Rev.	Description	Initiator	Date
02	ECO 13944: Added new Notes #1 and #2, and renumbered existing Notes; Changed Note #'s on callouts; Added images & Notes detailing tab removal.	MSD	11/10/2015

DRAWN BY: J. Winterroth, 11/26/13		TITLE	
CHECKED BY: D. Norton, 12/04/13		TSM Horizontal Module, 1520mm (60")	
PROJECT # -	SHEET 1 OF 1	SCALE	SIZE
		1:8	B
DRAWING NUMBER		REVISION	
9630-20-TSM-HM-3353		02

Tab Removal Instructions:

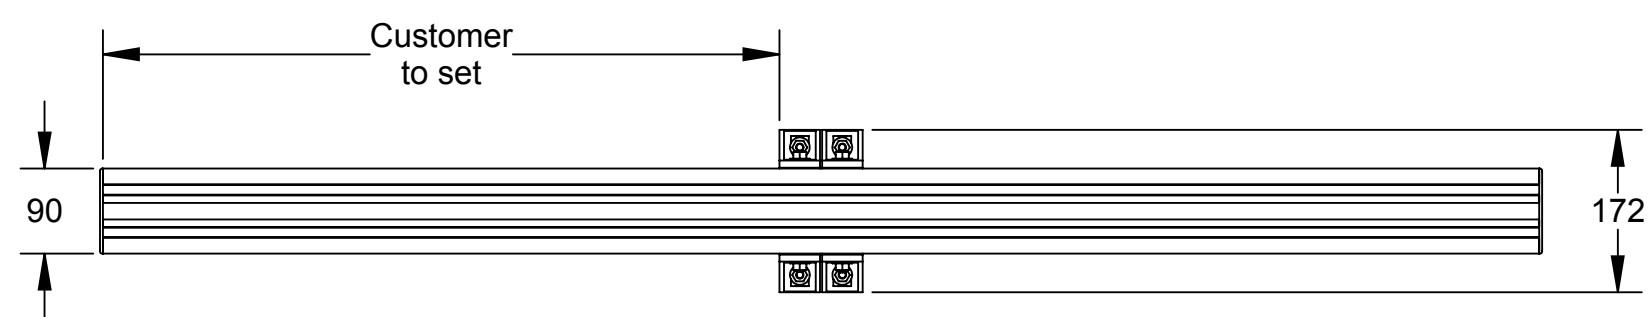
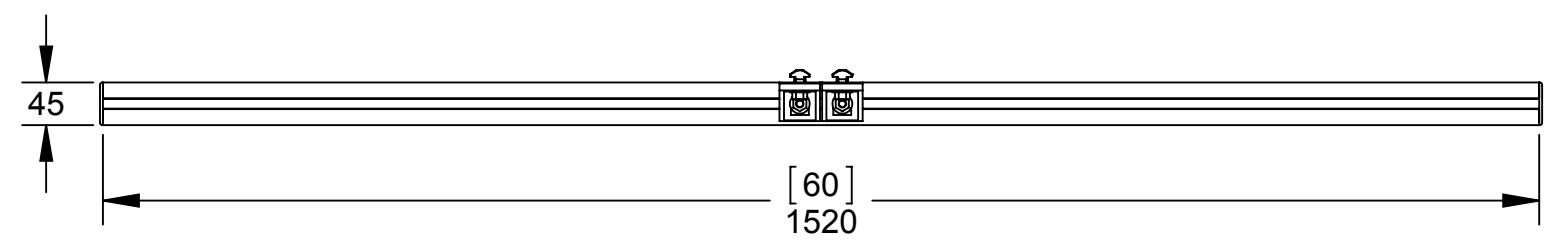
Remove the tabs on the Gusset face that will contact the Horizontal Rail
Note 1

Leave the tabs on the Gusset face that will contact the Post Module
Note 2

Pry up on a tab to break it off

1. Insert a screw driver into the slot under the tab.
2. Pry up on the tab to break it off.
3. Remove any burrs that may not allow flush contact to the base assembly.

1. Customer to remove Gusset tabs from the mating surface that contacts the Horizontal Rail.
2. Leave tabs on the Gusset mating surface that will contact the Post Module.
3. Customer to use Loctite or similar thread locker and torque fasteners to listed torque value.
